# Colotex Apparels Ltd

Plot:10/1, South Salna, Joydebpur, Gazipur, Bangladesh

07 June 2022

# Observations

Material strength shown in DEA report

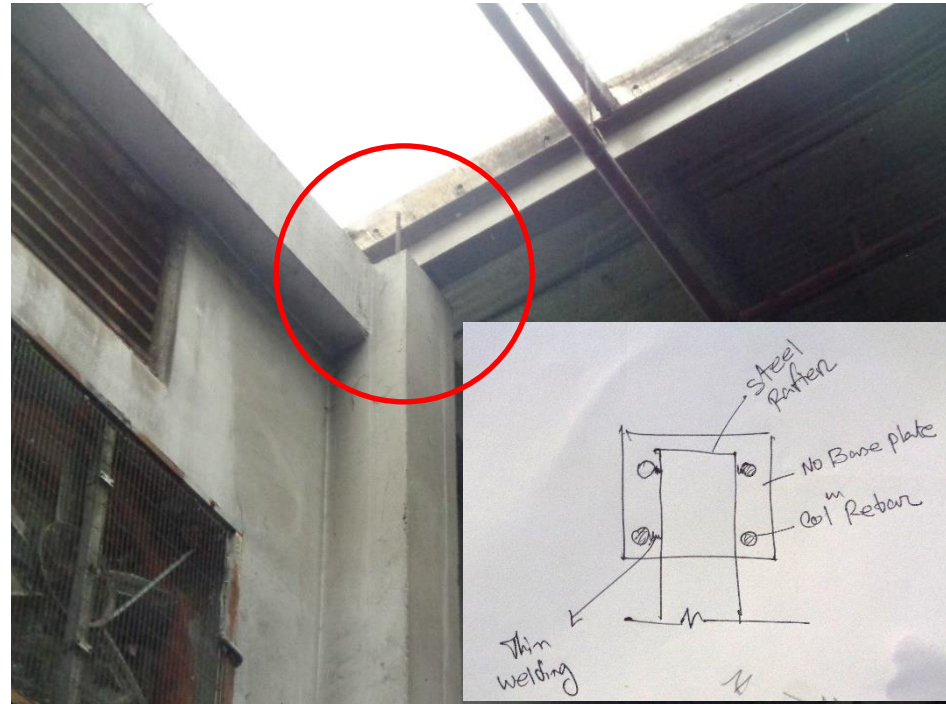
Strength of concrete (red marked) is considered for structural elements in Detail Engineering Assessment without any test report. Besides, contradictory information provided in Detail Engineering Assessment report. Design value of rebar is shown both as 415 MPa and 500 MPa (black marked). Factory engineer is required to update the Detail Engineering Assessment report as per in-situ material test data.

| Item No. | Observation                                                                             | Recommended Action Plan                                                                                            | Recommended Timeline |
|----------|-----------------------------------------------------------------------------------------|--------------------------------------------------------------------------------------------------------------------|----------------------|
| 05       | Material strength consideration in design report (Ansar Building)                       | Factory engineer is required to update the Detail Engineering Assessment report as per in-situ material test data. | 6-weeks              |
